RE: 583 Trail Road N plan review

Re: Akbar & Susan Boutorabi 583 Trail Road North Preliminary/Final Subdivision and
Land Development Plan
Our File No. 10221-1

Re: 583 Trail Road North (Boutorabi)
Preliminary/Final Subdivision and Land Development Plan
Township Permit No. 2026-03-FSDP
LCEC Project No: 25-211

**PROPOSED MOTION FOR THE PRELIMINARY/FINAL SUBDIVISION AND LAND DEVELOPMENT
PLAN
FOR AKBAR & SUSAN BOUTORABI – 583 TRAIL ROAD NORTH
M.J.T.P.C. File # 26-03-FSDP**

EXISTING CONDITIONS	
PROJECT: SUBDIVISION PLAN	PROJECT No.: 250610
Owner: Alter Boudorabi	SCALE: (H) 1"=50'
583 TRAIL ROAD NORTH	(V) N/A
LANCASTER COUNTY, PENNSYLVANIA	DATE: 2025.08.09
TITLE:	SHEET No: 2 OF 9
REV: 1	REV: 1

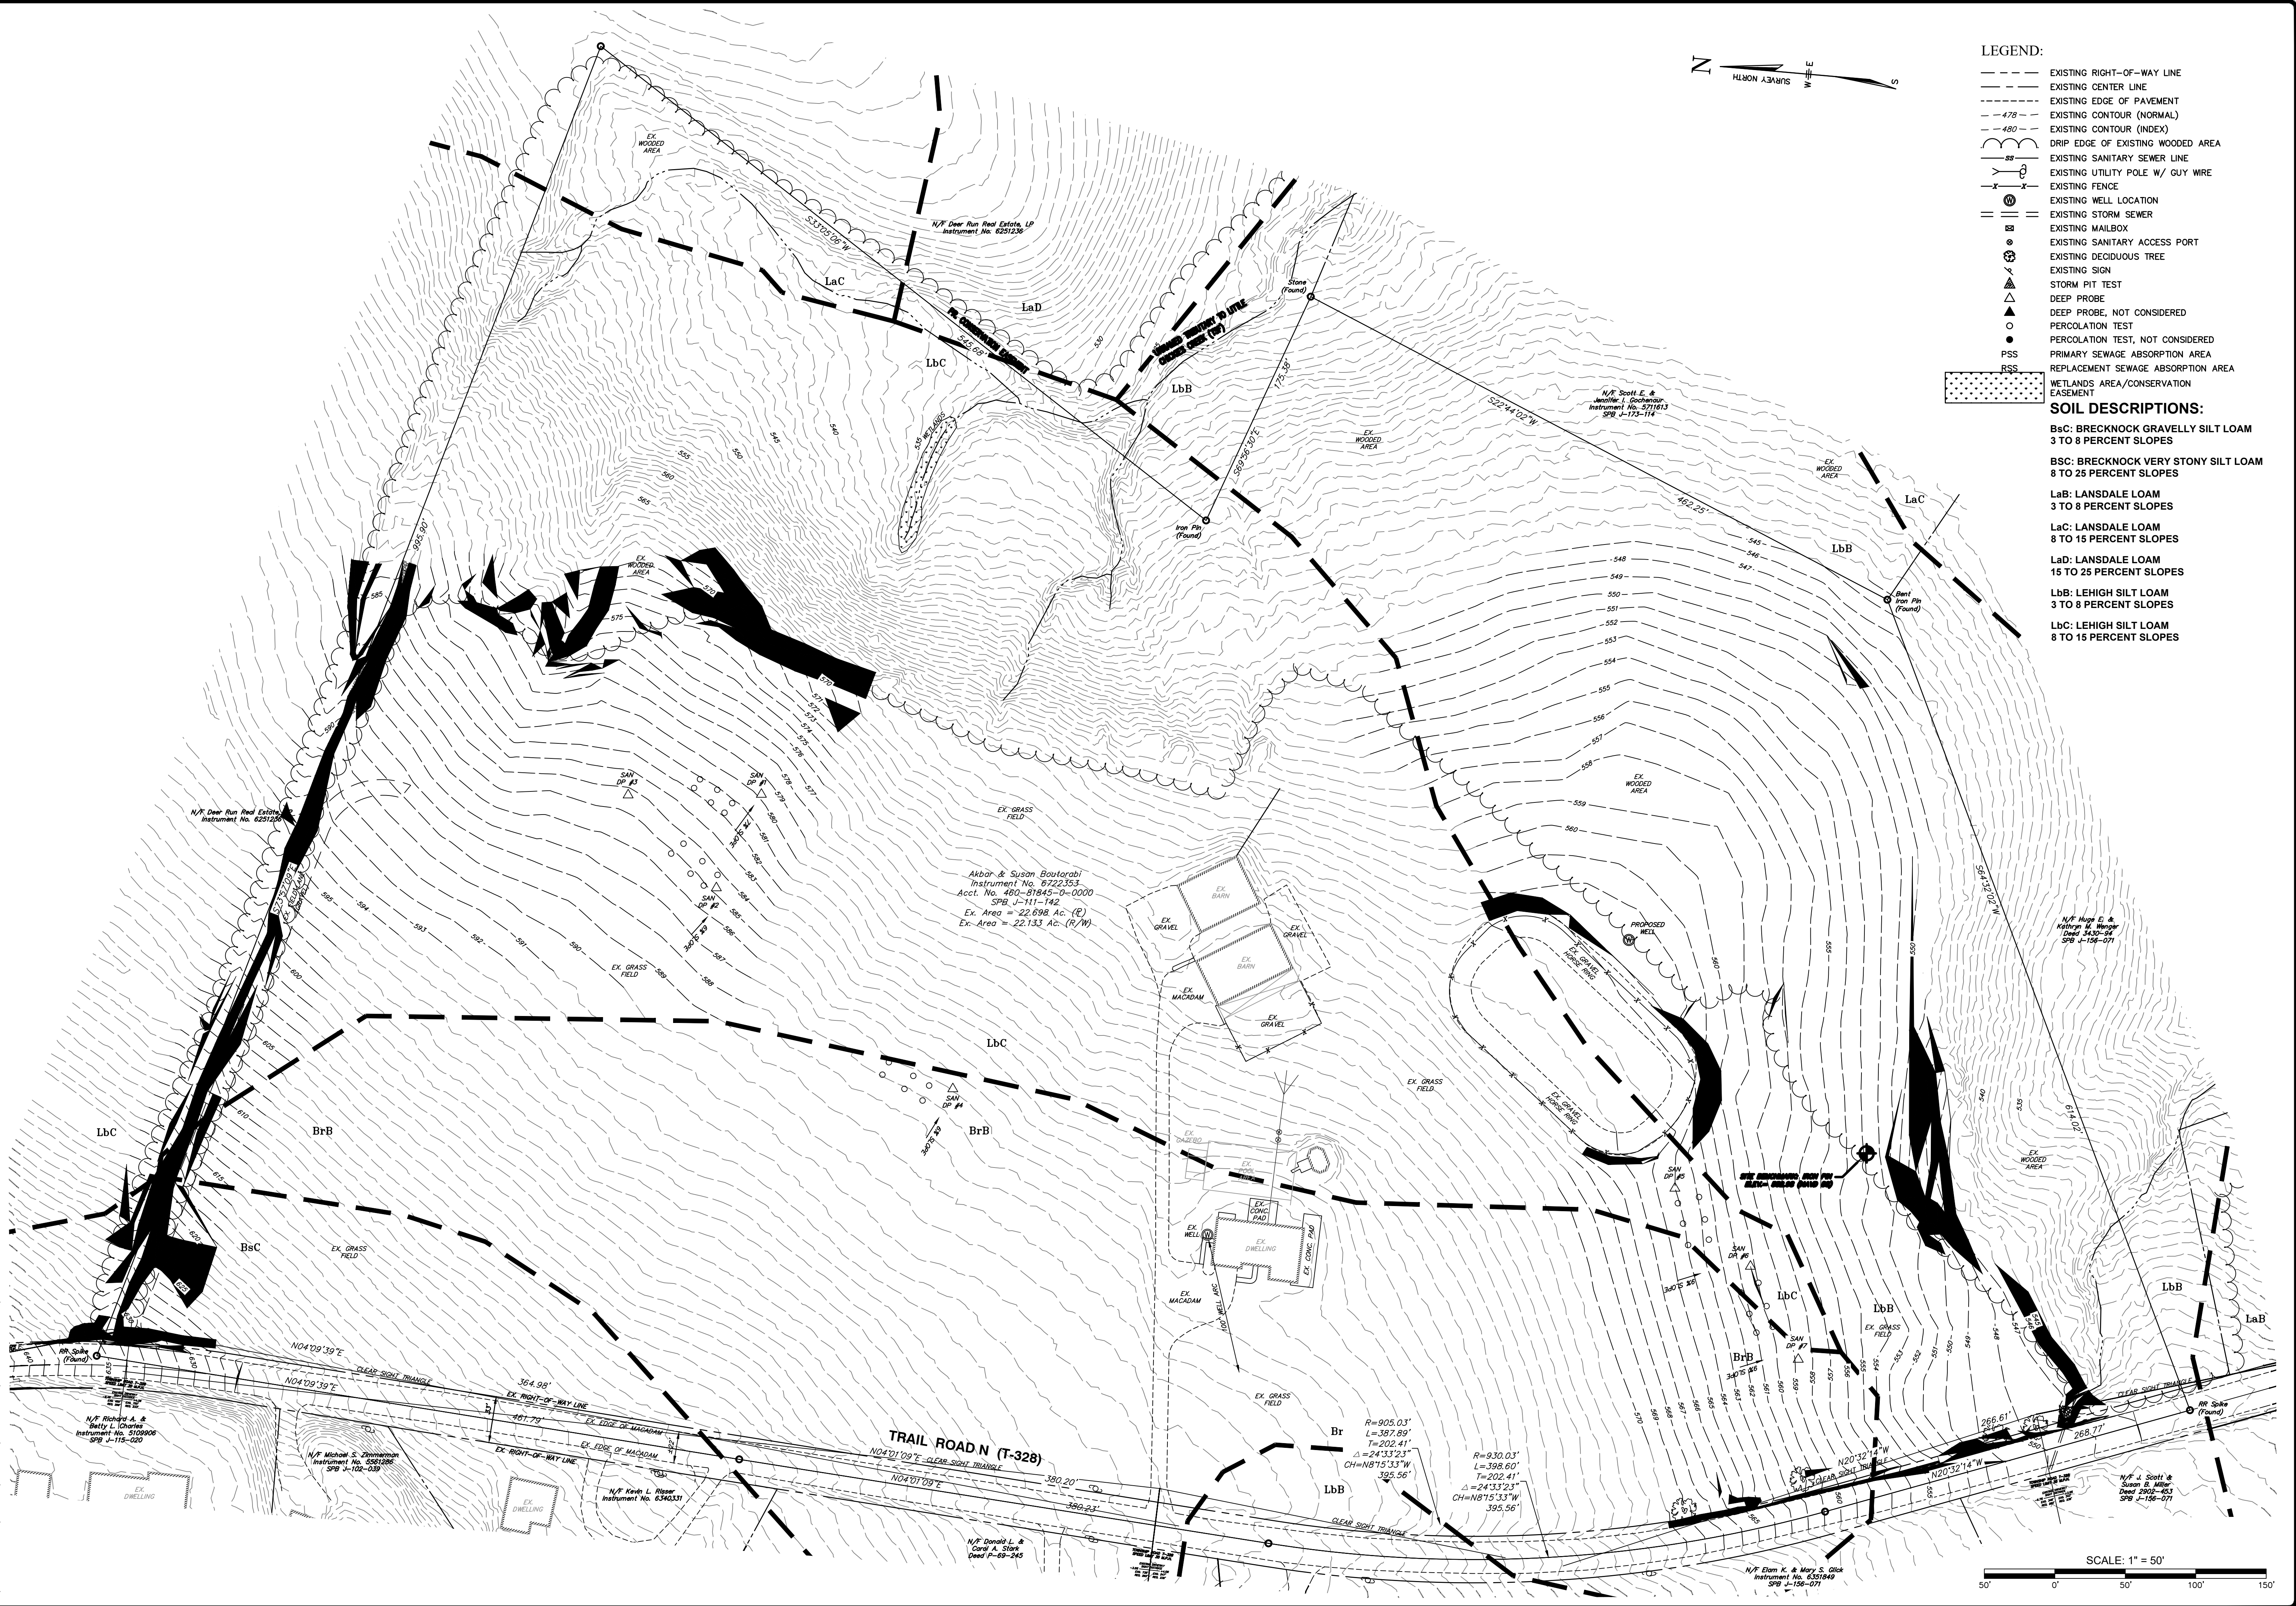
5. The revised plans show separate hatch types for the wetlands and conservation easement, but only one "Wetlands Area/Conservation Easement" hatch is shown in the legend on Sheet 2. Each hatch shall be clearly labeled or identified in the legend (135-307B & .E).

10. The hatch/line type of the existing gravel shown on Sheets 2 and 3 is inconsistent with the hatch/line type of the existing gravel shown on Sheets 4, 5, 6, and 7 (119-31.A(4)). This makes it appear that there are improvements being proposed to the existing driveway. This shall be clarified on the plans.

16. The density shown in the Site Data table on Sheet 1 shall be corrected (119-31.D(3)).
17. Bearings and distances shall be provided for the existing right-of-way on Proposed Lot No. 1 (119-31.D(4)).

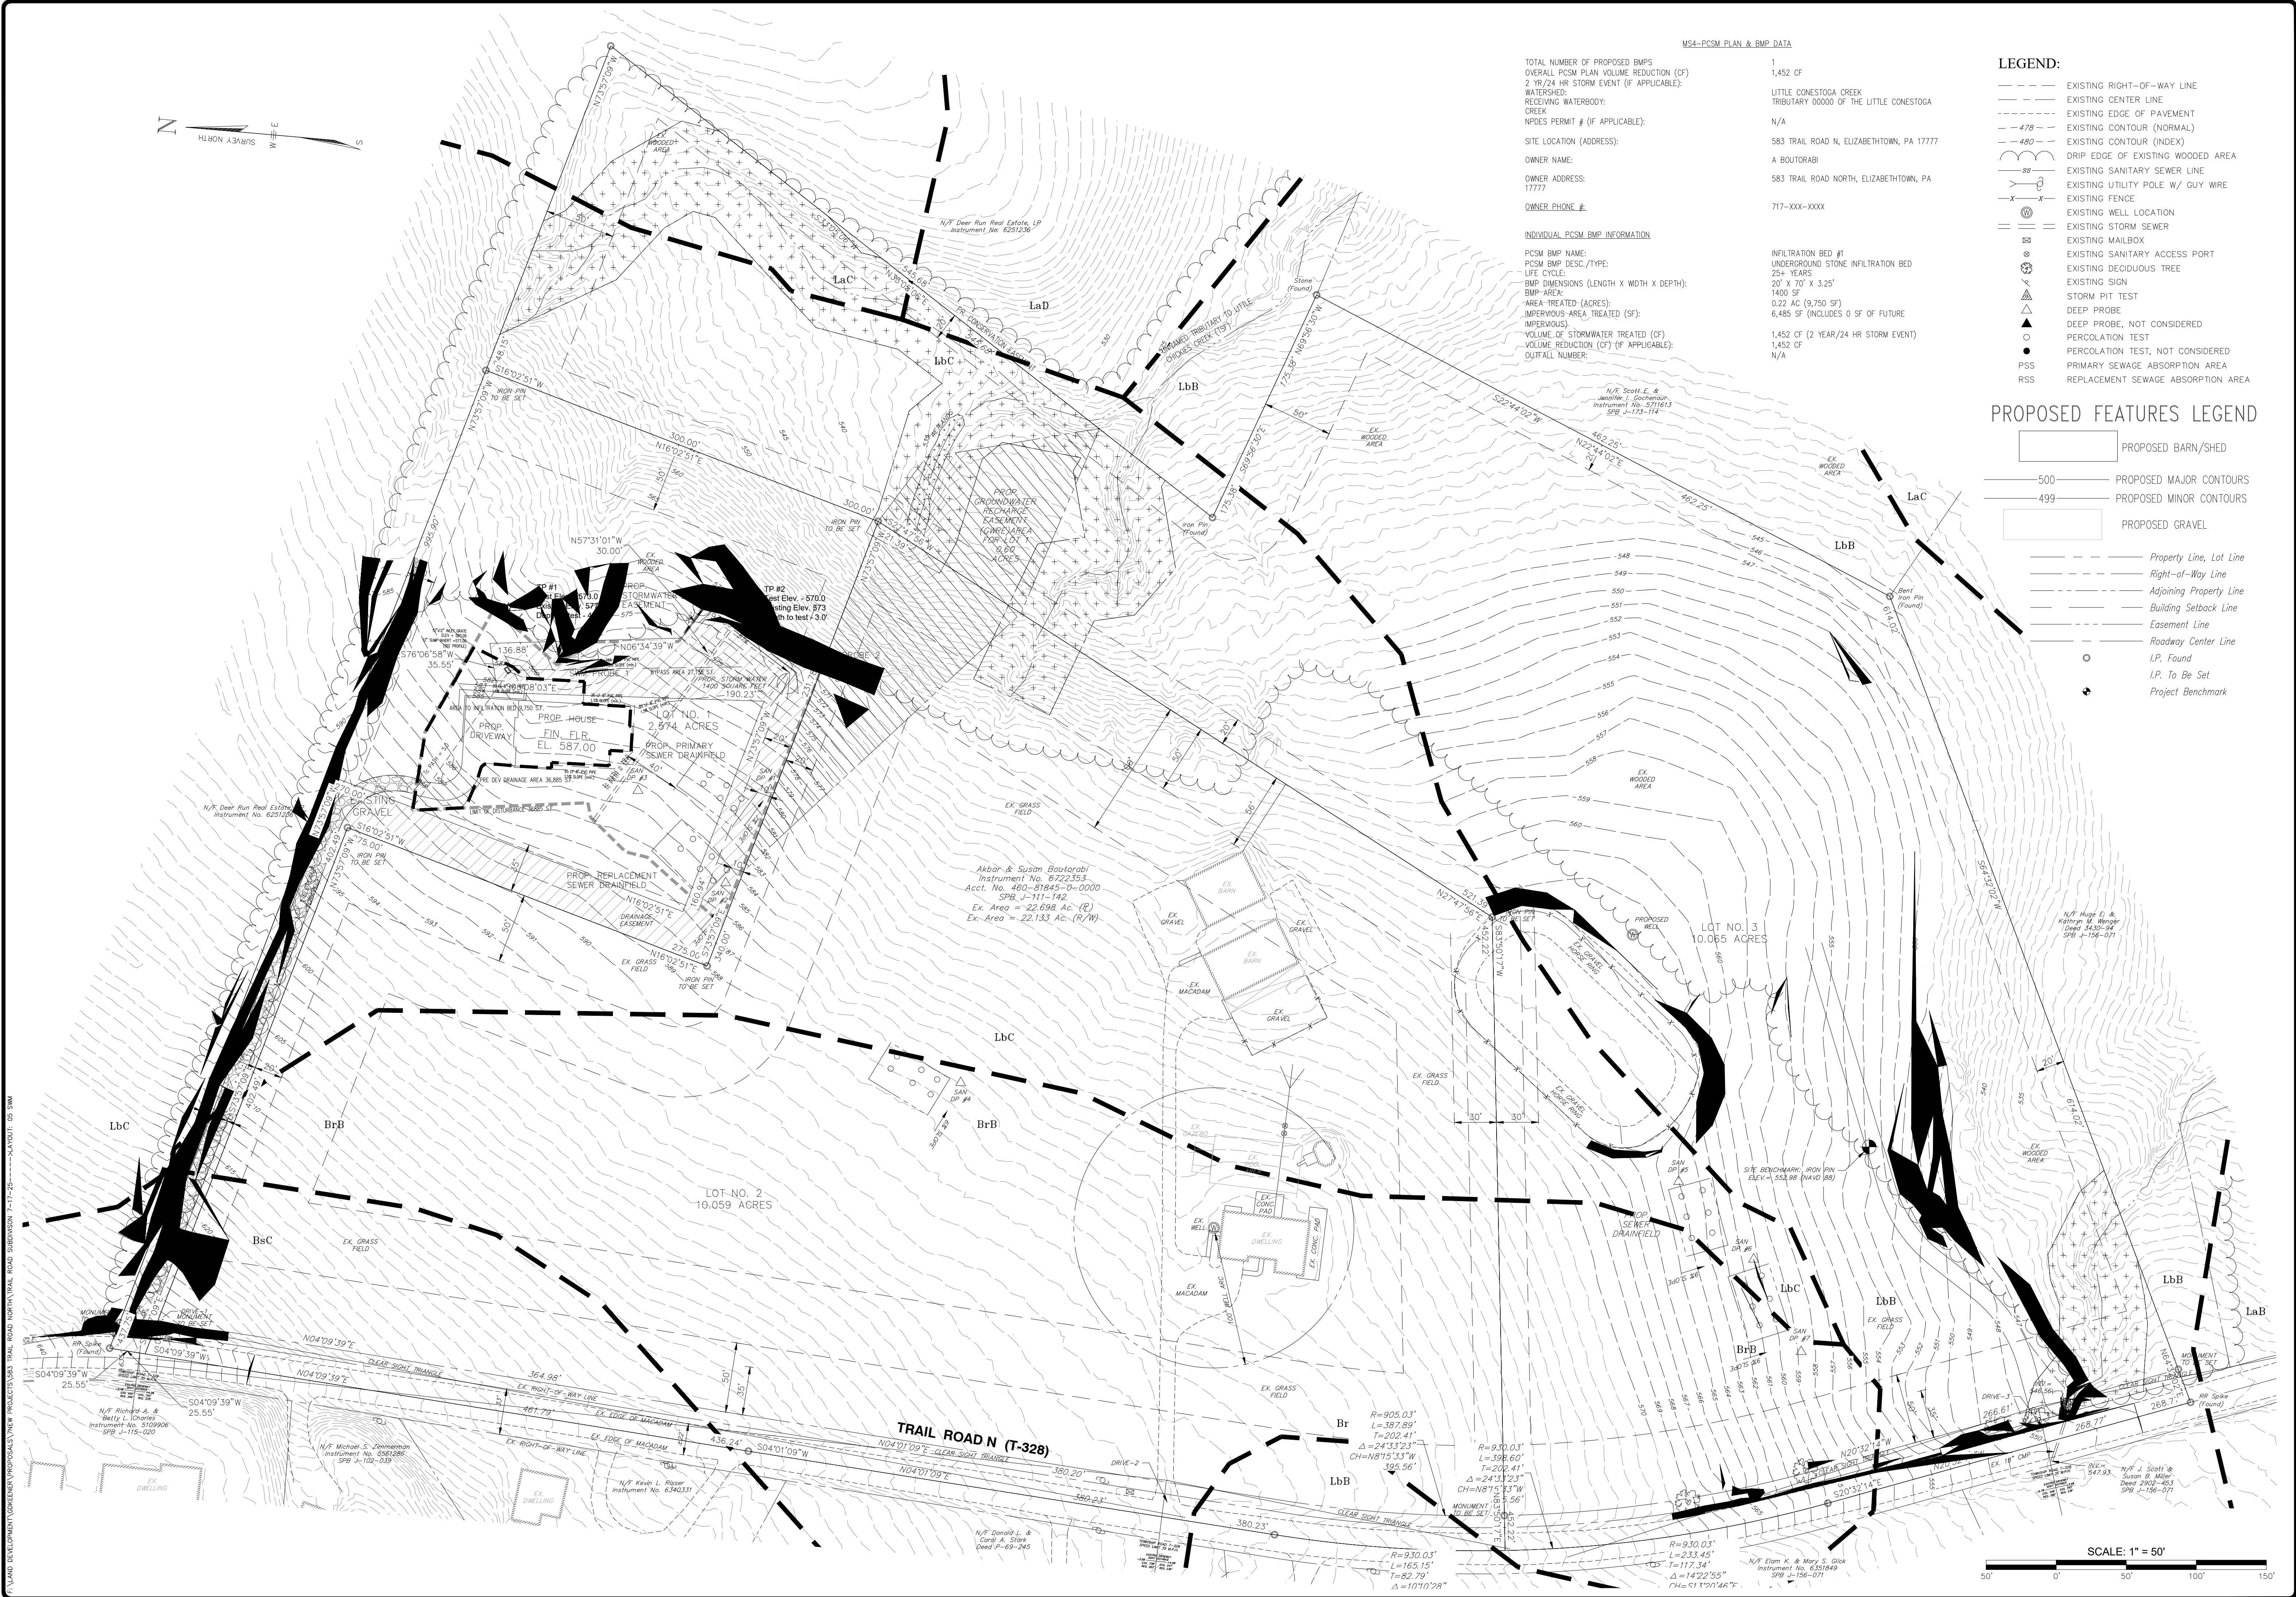
9. The Proposed Barn/Shed shown in the proposed legend on Sheet 5 shall be shown on the plans (or removed from the legend if a barn/shed is not being proposed) (119-31.A(4)).

32. A minimum thirty-foot-wide access easement shall be provided for all stormwater facilities with tributary areas equal or greater than 1,000 square feet and not located within a public right-of-way (113-31.Q). A portion of the proposed drainage easement shown on Sheet 5 of the plans is not thirty feet wide. The proposed drainage easement also conflicts with the rear of the proposed house which does not allow the required width to be provided.

41. The depth of the Infiltration Bed shown in the MS4-PCSM Plan & BMP Data table shall be updated to match the revised depth (113-45.J(5)).
42. The expected project schedule shall be added to the plans (113-44.E). This comment was acknowledged, but not addressed.
